SUPPLEMENTAL SPECIFICATIONS

1988 English Standard Specifications for Highways and
Bridges

APRIL 1, 2019

The 1988 English and 1995 Metric Standard Specifications for Highways and Bridges are amended by the following modifications, additions and deletions. These are supplemental specifications and shall prevail over those published in the Standard Specifications for Highways and Bridges. This supplement incorporates all previous Error & Addenda sheets, and Supplemental Specifications, and therefore supersede all previous supplements and addenda.

Figure 1 - Notched Wedge Joint

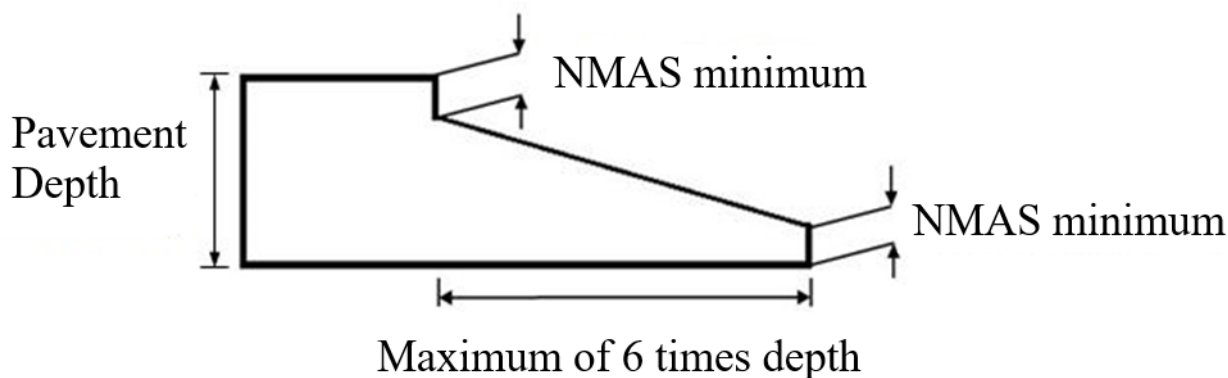
The Contractor may use a longitudinal wedge joint when placing HMA pavement courses at a thickness of 1.25 inches to 3.75 inches as shown in Figure 1 below. In instances where the joint will not be subjected to traffic prior to the adjacent pass being placed the maximum thickness may be increased to 5 inches.

When a wedge joint is proposed for use, the joint detail shall be included in the Contractor's QC Plan. The wedge joint shall include a notched vertical edge with a minimum depth equal to the nominal maximum aggregate size (NMAS) at the top and bottom of the wedge. The sloped surface of the wedge joint shall not exceed a 6:1 slope. The width of the wedge shall not exceed 6 times the pavement depth. The Contractor shall use a commercially manufactured wedge joint attachment to the paver, or other attachment approved by the Engineer, to form the wedge joint.

Hot poured rubberized asphalt sealant shall not be applied to wedge joints. A tack coat shall be applied to the entire surface of the wedge joint in accordance with Subsection 450.43 prior to placement of the adjacent pull of HMA.

FIGURE 1

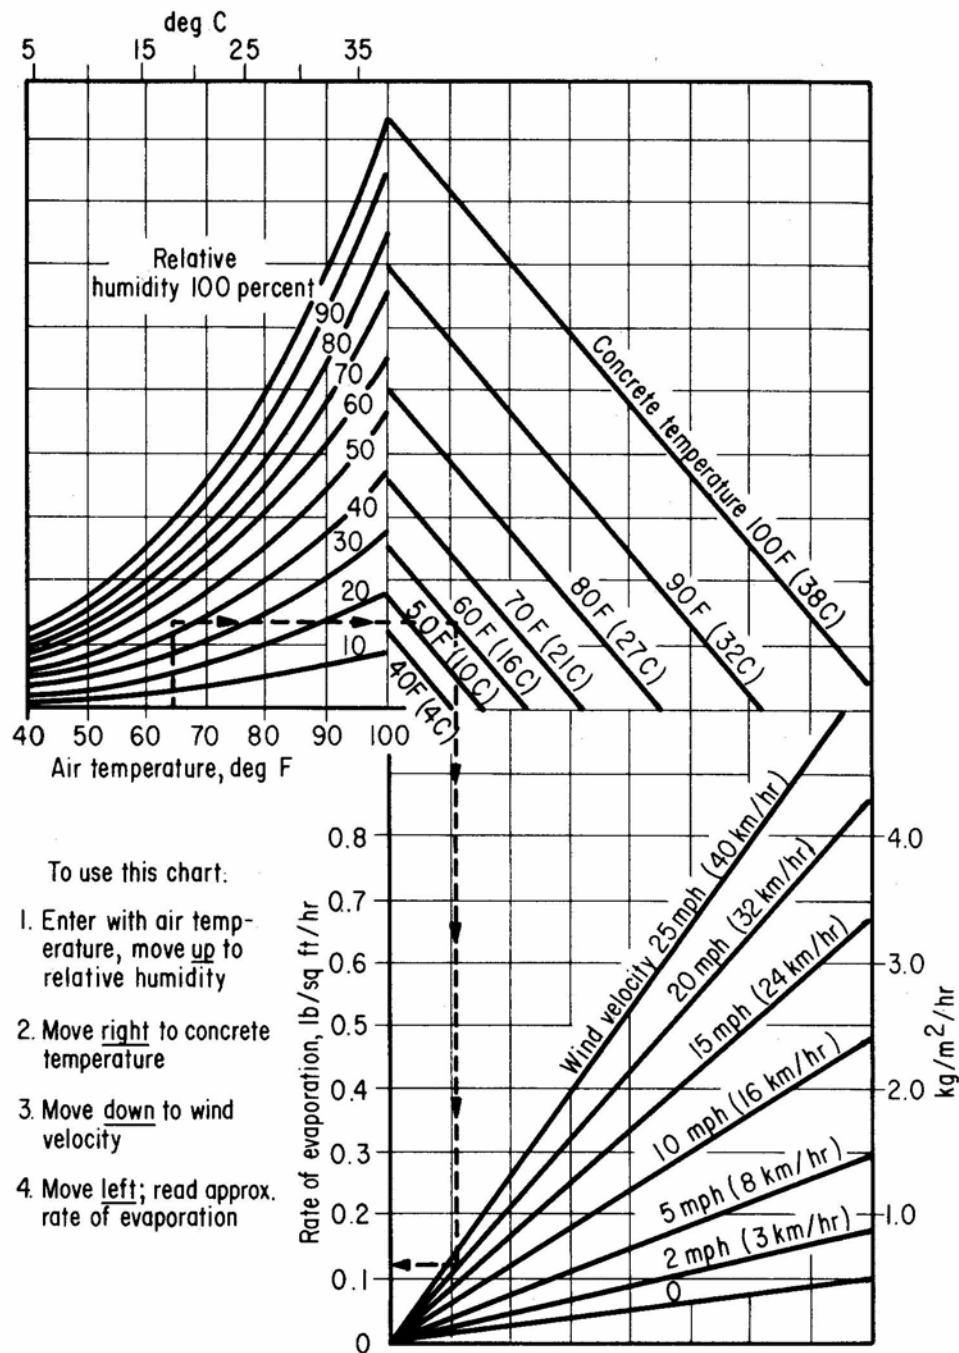
The weight of the finishing machine(s) shall not cause unaccounted deflection of the bridge members or falsework. The machine shall travel on steel rails, pipe or other approved grade control, which shall be supported by vertical supports securely fastened in place at a maximum spacing of 2 feet (200 mm) to prevent any appreciable deflection between rail supports. Screed rail supports may be located inside or outside of the placement width. Prior to placing the concrete, screed rails shall be completely in place, and accurately set to insure finishing of the concrete deck surface to the elevations shown on the Plans. The supports for the rails, if embedded in the deck concrete, shall be of the type that can be removed without disturbing the concrete.

Screed rails shall be set entirely above the finished surface of the concrete and shall be supported in a manner approved by the Engineer. Where stud type shear connectors are available, welding to the studs will be permitted. Where no studs are available, other means of attaching the screed rail supports shall be provided. No welding will be permitted directly on stringer or girder flanges or cover plates in tension areas, nor in areas subject to stress reversal, for attaching either screed rail supports of any type. Any welding in compression areas shall be approved by the Engineer.

Screed rail supports set in the concrete shall be so designed that they may be removed to at least 2 inches (50 mm) below the surface of the concrete. Voids created by removal of the upper part of the screed rail supports shall be filled with mortar having the same proportions of sand and cement as that of the slab or wearing surface. The mortar shall contain an approved additive in sufficient proportions to produce non-shrink or slightly expansive characteristics. Screed rail supports shall not be treated with parting compound to facilitate their removal. Rails for finishing machines shall extend beyond both ends of the scheduled length for concrete placement. The extended length shall be of sufficient distance to allow finishing machine(s) to clear the concrete to be placed.
